MILWAUKEE
HISTORIC
PRESERVATION
COMMISSION

Certificate of Appropriateness

2333 S. 6TH ST. St. Josaphat Basilica, an individually designated property

PTS ID 108615 COA replace damaged stone, copper flashing, repointing as needed

Locations at which deteriorated stone and copper will be replaced.

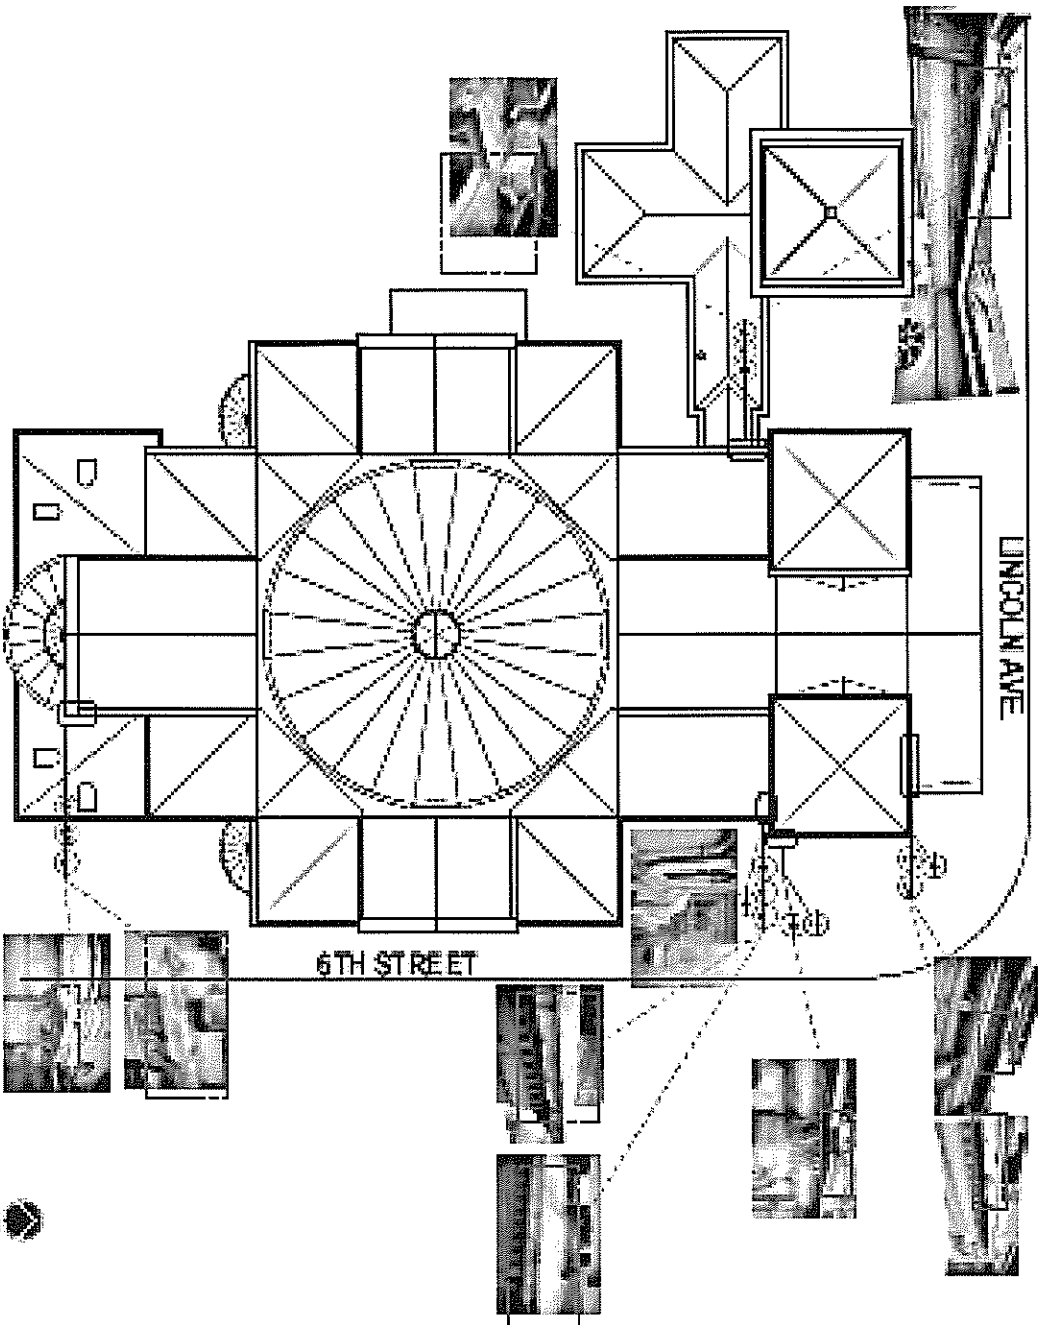
All work is to be carried out per the application and bid documents. New sandstone will come from the Sciota Stone Quarry in Sciota, Ohio from which the original stone came. Mortar will be matched to the original in color, composition, strength and tooling.

Historic Preservation staff will review and approve the stone before installation.
